Minutes of the Design Review Panel Meeting 4 – March 29, 2011

Scarborough Centre Streetscape and Open Space Plan	
Planning Area	Scarborough Centre
Design Team	DTAH/ARUP/SWERHUN/JAMES URBAN/UFU/URBANMETRICS
Application Type	n/a
Review	First
City Staff	Robert Stephens, Urban Design Kelly Dynes Community Planning
Conflict of Interest	None
Vote	n/a

Etobicoke Centre Streetscape and Open Space Plan	
Planning Area	Etobicoke Centre
Design Team	Urban Strategies Inc., The MBTW Group, GHD
Application Type	n/a
Review	First
City Staff	Robert Stephens, Urban Design Kelly Dynes Community Planning
Conflict of Interest	None
Vote	n/a

424 - 460 Adelaide St East	
Planning Area	King-Parliament
Design Team	Kirkor Architects & Planners STLA Design Strategies
Application Type	Rezoning
Review	Second (1 st review Oct. 2009)
City Staff	Myron Boyko, Urban Design Willie MacRae, Community Planning
Conflict of Interest	Sibelle von Knobloch
Vote	<u>Support – 8</u> ; Non-support - 0 Condition: Employ retail at terminus base and explore greater tower setback to north and west

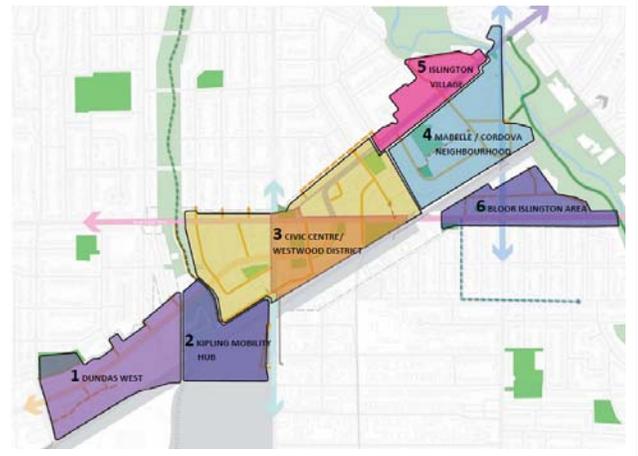
Wood Lots

The wood lots were identified as being very important edges. Noting the sensitive nature of the understory, the Panel indicated that management of these lots may be necessary to ensure long-term damage is minimized. In order to address the challenge of increasing the population within this precinct, some members felt that it would be appropriate to develop the civic common between the two wood lots. The majority of members, however, disagreed with this suggestion.
